## Explanation of Significant Differences to the Record of Decision for Potential Source of Contamination 16 Former Building 7100 PCB Area Marine Corps Logistics Base Albany, Georgia

### SUMMARY OF EXPLANATION OF SIGNIFICANT DIFFERENCES

This Explanation of Significant Differences (ESD) documents significant changes to the remedy established in the 1992 IROD and 1997 ROD.

**FIGURE 3**  
**PROPOSED EXCAVATION AREA**  
**POTENTIAL SOURCE OF CONTAMINATION 16**  
**MARINE CORPS LOGISTICS BASE**  
**ALBANY, GEORGIA**

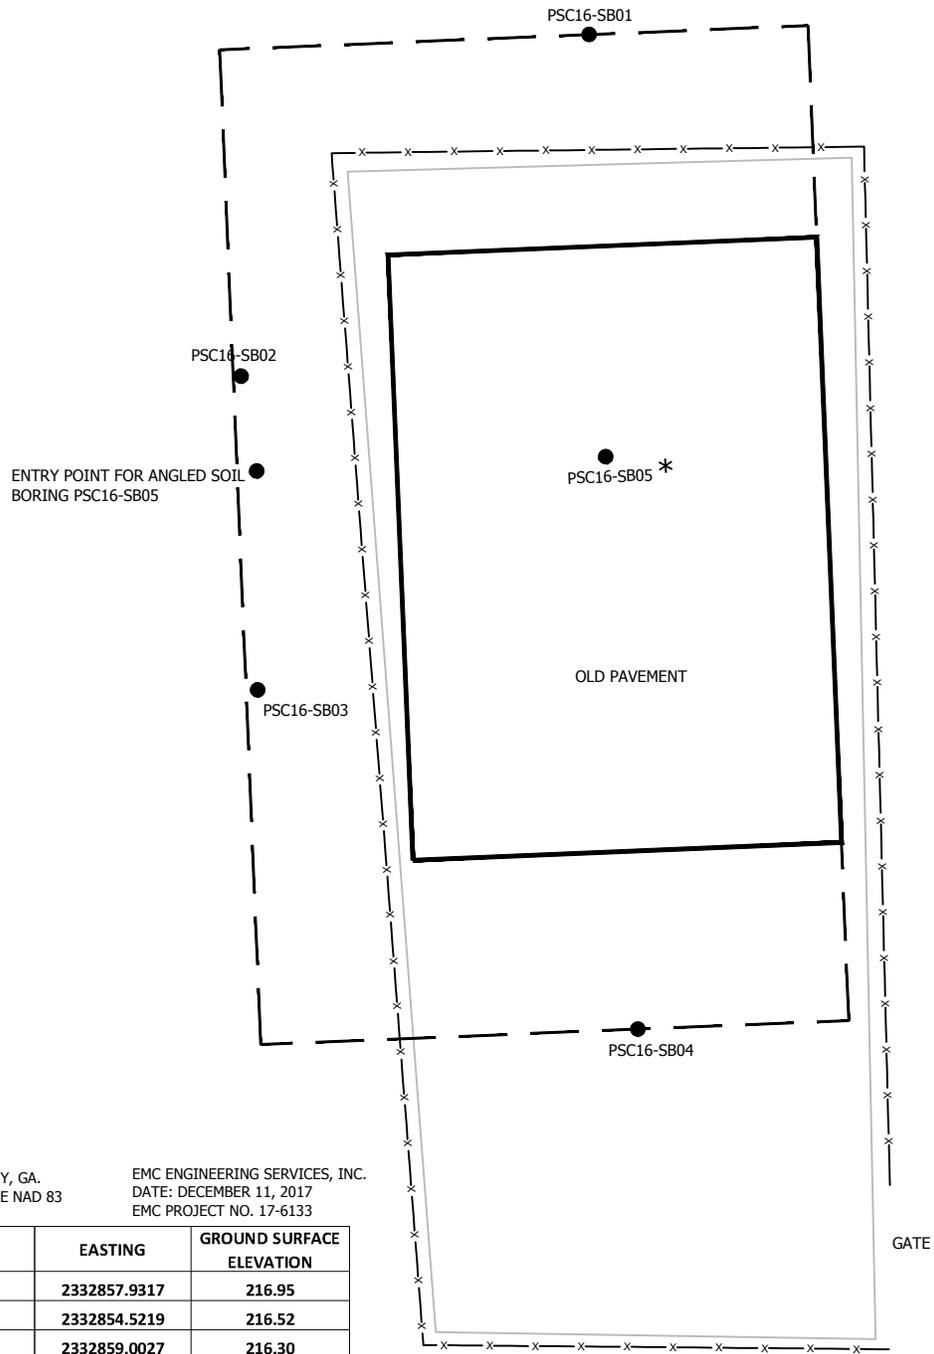
This ESD presents the modified remedy which was included as a remedial alternative in the 1992 RI/FS, Alternative 5A, and is presented in the table above. The estimated area of excavation is depicted in Figure 3. The modified remedy will consist of the following:

- Removal of the existing engineered cap and security fencing;
- Excavation of approximately 230 cubic yards of PCB-contaminated soil that exceeds the cleanup level of 1 ppm (which is based upon residential use);

- Collection of soil confirmation samples;
- Characterization and segregation of excavated PCB-contaminated soil. Contaminated soil with  $\geq 50$  milligrams per kilogram [mg/kg or ppm] PCBs is regulated for disposal under TSCA as PCB waste. Soil  $< 50$  ppm is considered PCB remediation waste.

The excavation of residual PCB-impacted soils above 1 ppm, which is cleanup level for soil without further use restrictions, will eliminate the requirement to maintain LUCs. The proposed excavation will be approximately 26 by 17 feet and extend to 14 feet bgs totaling approximately 230 cubic yards. Confirmation that no contamination is present in the groundwater media above drinking water standards supports a finding that no response action is necessary. The proposed remedy modification along with the confirmation of no actionable groundwater contamination is present in the PSC 16 footprint will achieve the RAOs; thus, resulting in the determination that PSC 16 is suitable for UU/UE and supports a delisting from the NPL when that process is pursued at a later date.
